PROPOSED TECHNICAL SPECIFICATION CHANGE

SEQUOYAH NUCLEAR PLANT UNITS 1 AND 2

(TVA-SQN-TS-88-42)

DESCRIPTION AND JUSTIFICATION FOR
MODIFICATION OF THE TRIP SETPOINT AND ALLOWABLE
VALUE UNITS FOR THE INTERMEDIATE RANGE NUCLEAR
FLUX DETECTOR AND CHANGES TO THE APPLICABILITY
REQUIREMENTS FOR THE SOURCE RANGE
NUCLEAR FLUX DETECTOR

SECTION 6.0 (CONT'D)

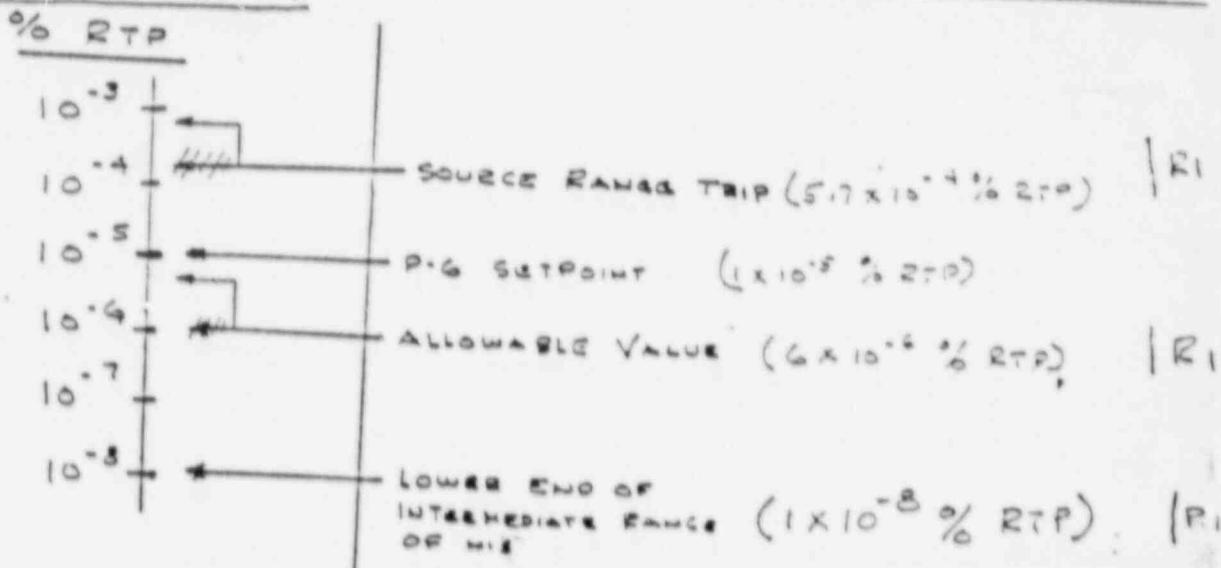
TO BE ABLE TO SHOW THESE BLOCK & TRIP SETPOINTS ON THE SAME SCALE FOR COMPARISON PURPOSES WE CALCULATE THE ACTUAL SOURCE RANGE TRIP IN % RTP BY PERFORMING THE FOLLOWINGS:
